SUBJECT: Grand Gulf Nuclear Station
Unit 1
Docket No. 50-416
License No. NPF-29
Alternate Decay Heat Removal System
Proposed Amendment to the Operating
License (PCOL-88/17)
AECM-88/0186

System Energy Resources, Inc. (SERI) is submitting by this letter a proposed amendment to the Grand Gulf Operating License. This amendment requests changes to the Grand Gulf Unit One Technical Specifications due to the proposed addition of the Alternate Decay Heat Removal System (ADHRS).

TABLE 3.3.7.1-1
RADIATION MONITORING INSTRUMENTATION

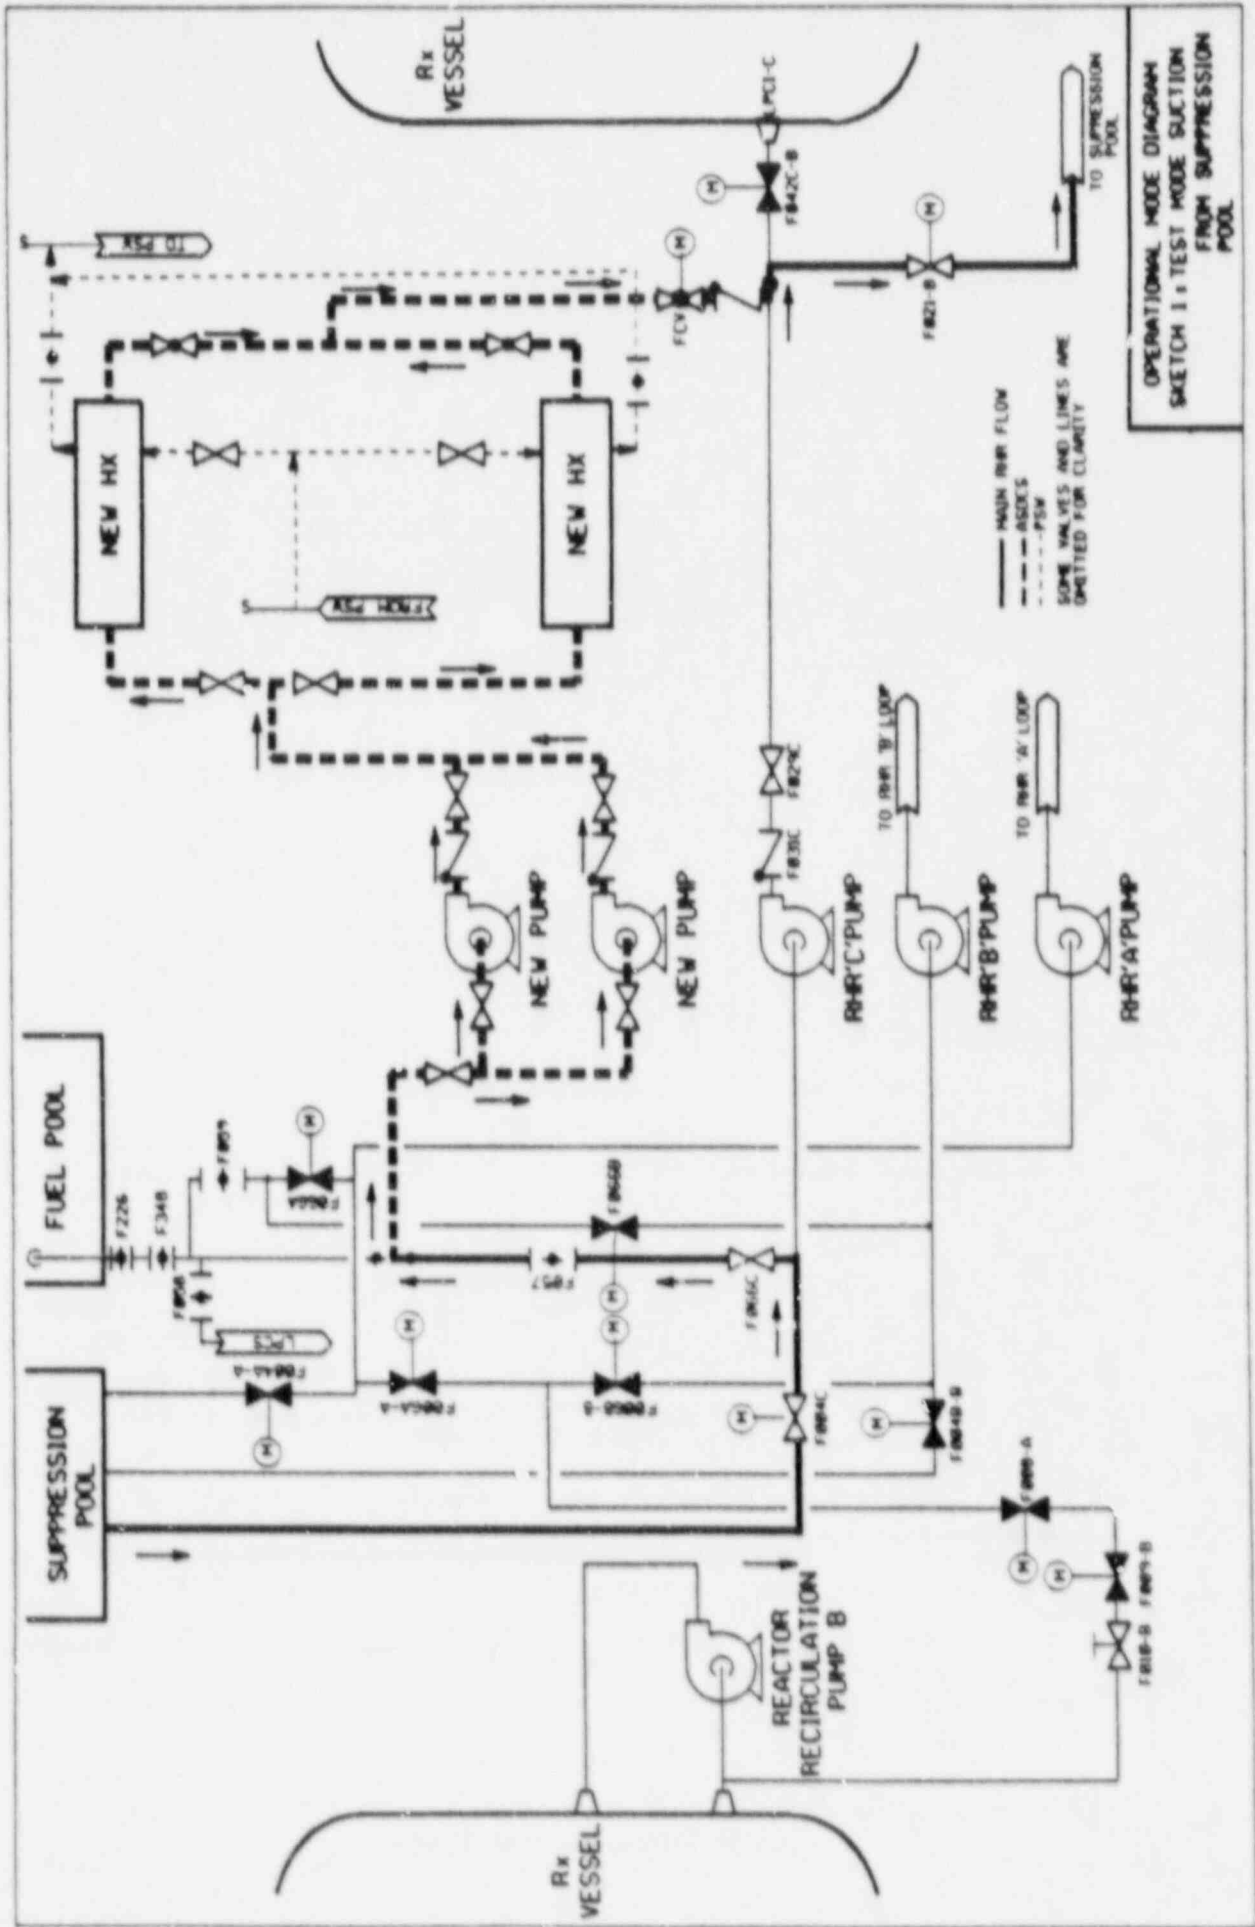
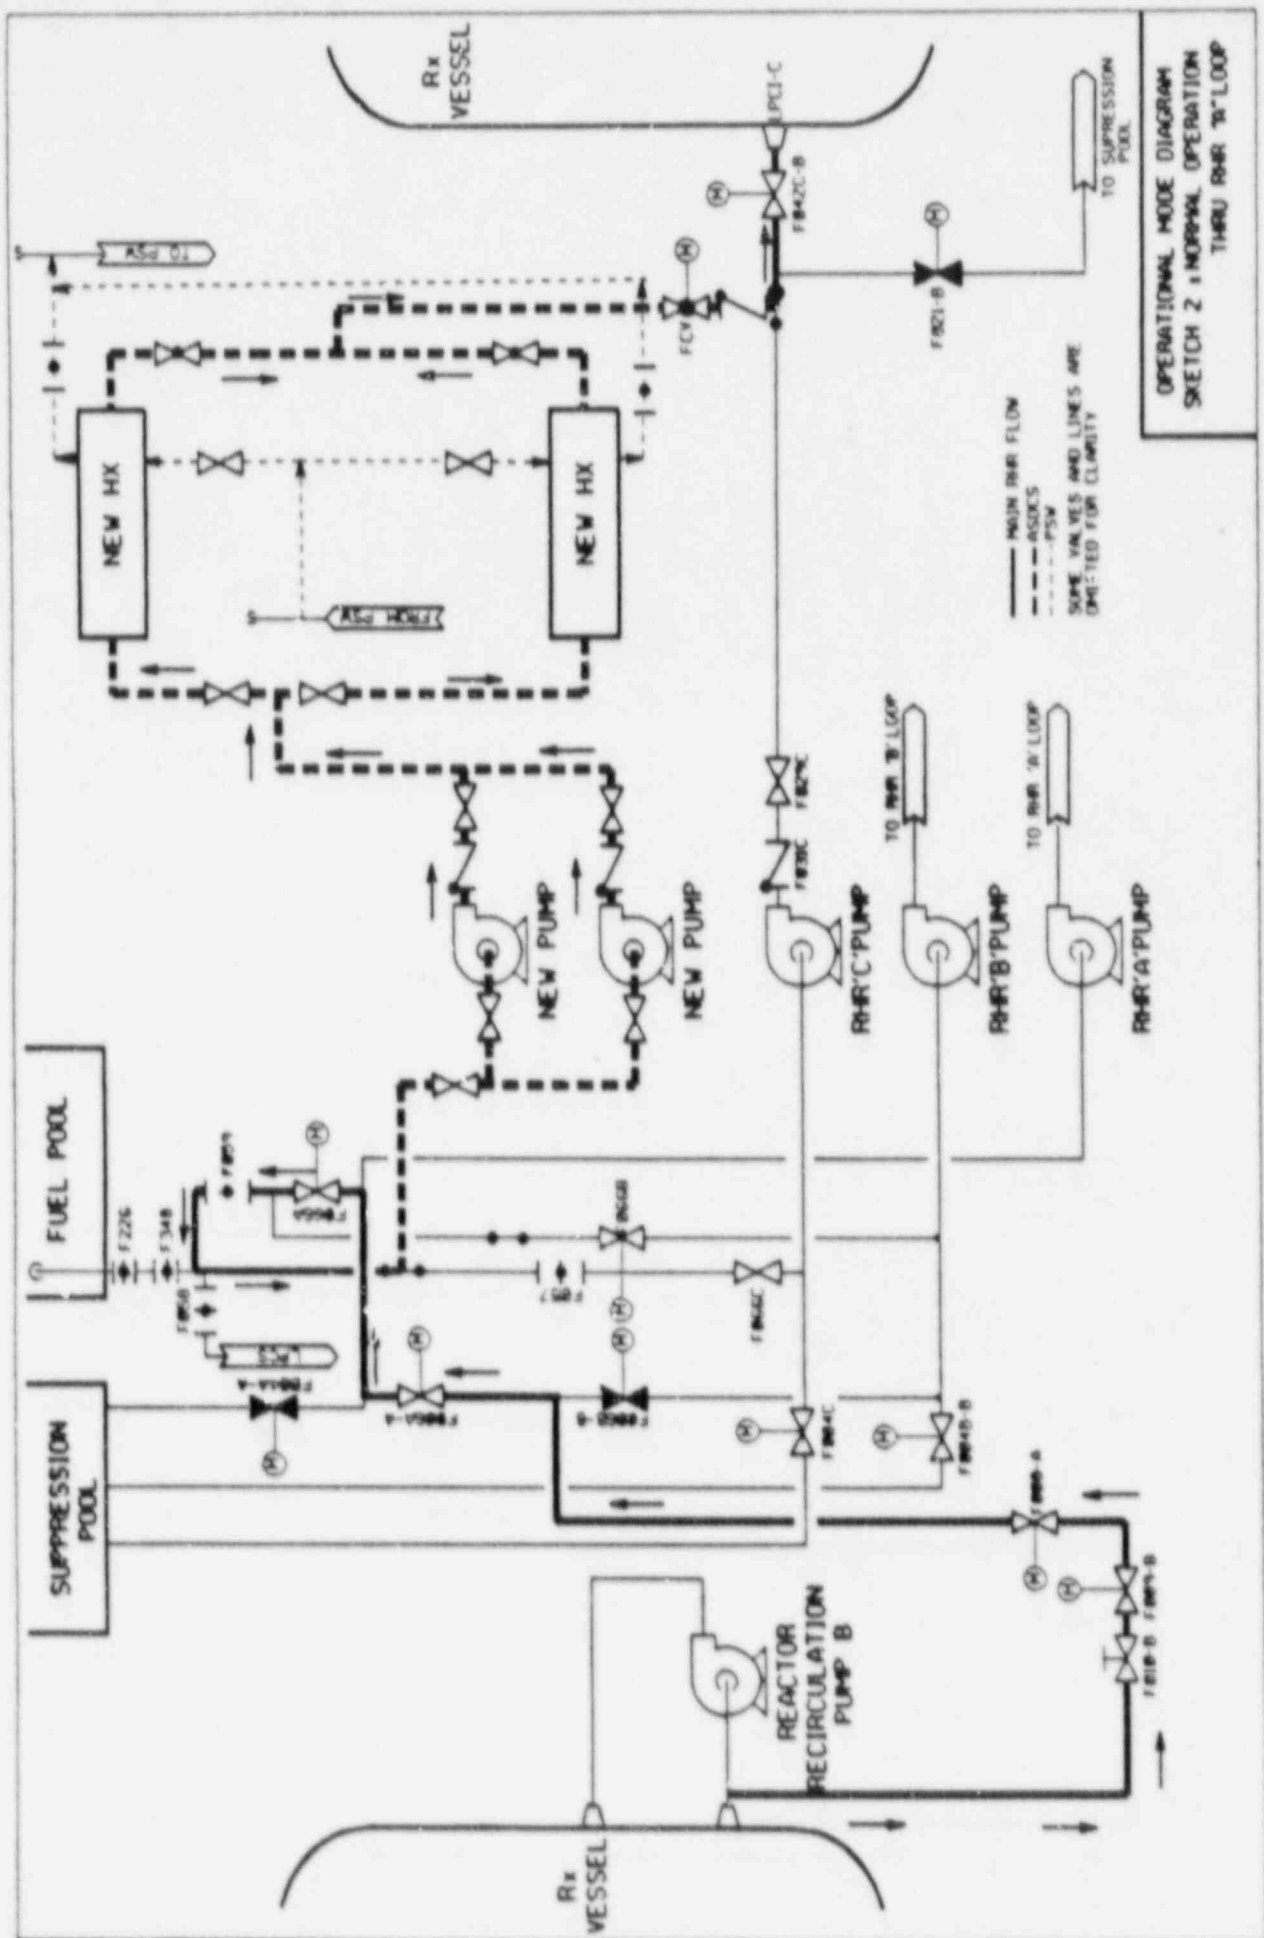
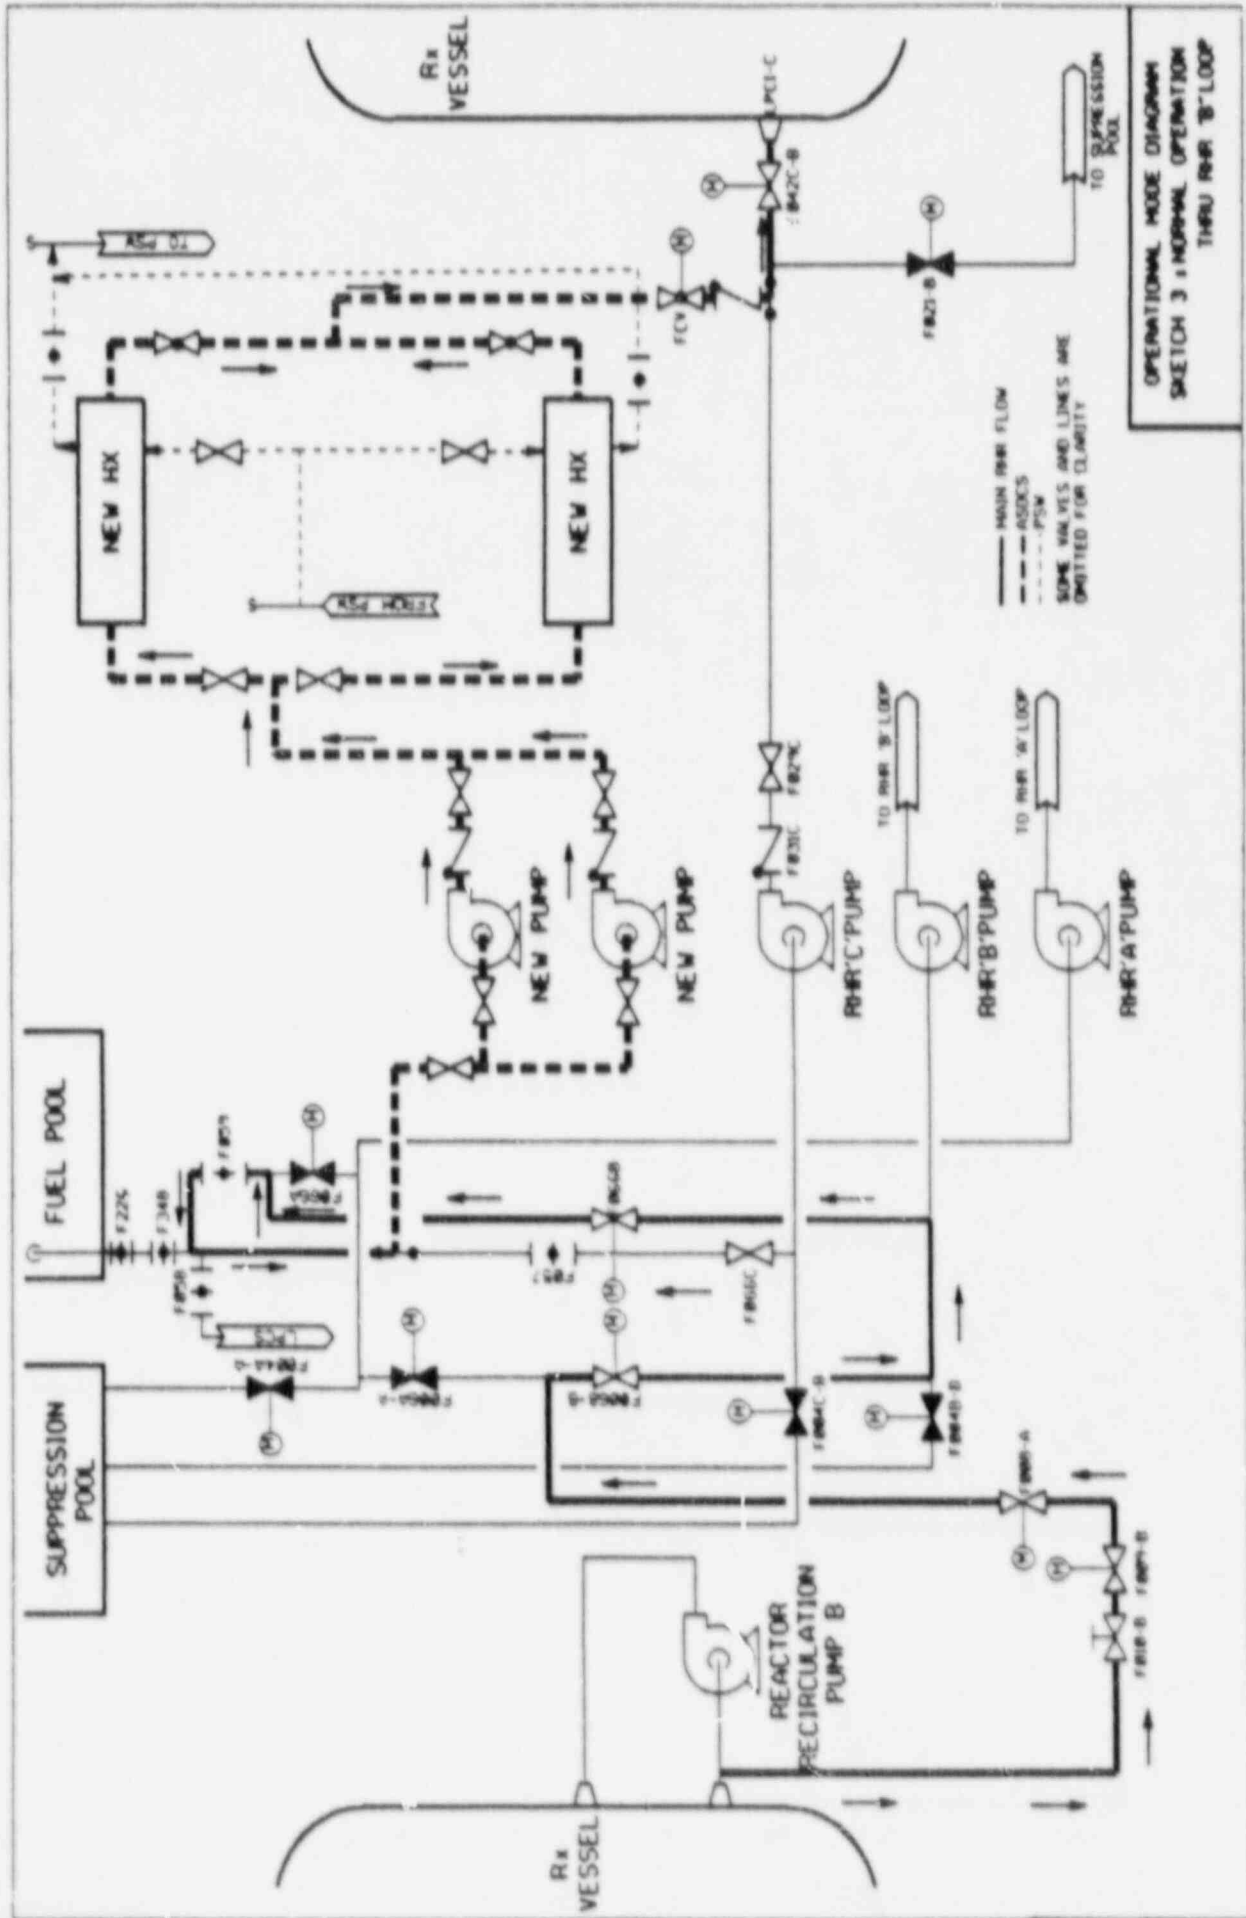
- a) The new PSW radiation monitor will be added as Item 3 of Table 3.3.7.1-1 (pg. 3/4 3-59). Only one channel will be required operable anytime the new ADHRS heat exchangers are in operation. The applicable conditions of operability will be specified using a new footnote ## which will state:

Surveillance requirements for the new PSW radiation monitor will be added as item 3 of Table 4.3.7.1-1 (pg. 3/4 3-62). The surveillance requirements will be identical to those of the CCW and the SSW radiation monitors. A channel check frequency of 'S' (i.e., at least once per 12 hours) will be

- b) The new thermal overload protection devices for valves E12F066A and E12F066B will be added to Table 3.8.4.2-1 (pg. 3/4 8-48) and included with the other RHR system thermal overload devices. The bypass device column for these two new valves will read "Continuous", meaning that these thermal overload protection devices are continuously bypassed except during testing of the motor operator. The affected system column will read "RHR System".

2. Standby Service Water System Radiation Monitor	1/heat exchanger train	1, 2, 3, and*	$< 1 \times 10^5$ cpm/NA	10 to 10^6 cpm	70
Plant Service Water System Radiation Monitor	1	##	$\leq 1 \times 10^5$ cpm/NA	10 to 10^6 cpm	70

2. Standby Service Water System Radiation Monitor	S	M	A	1, 2, 3, and*
3. [DELETED] Plant Service Water System Radiation Monitor	S	M	A	#
4. [DELETED] Carbon Bed Vault Radiation Monitor	S	M	A	1, 2
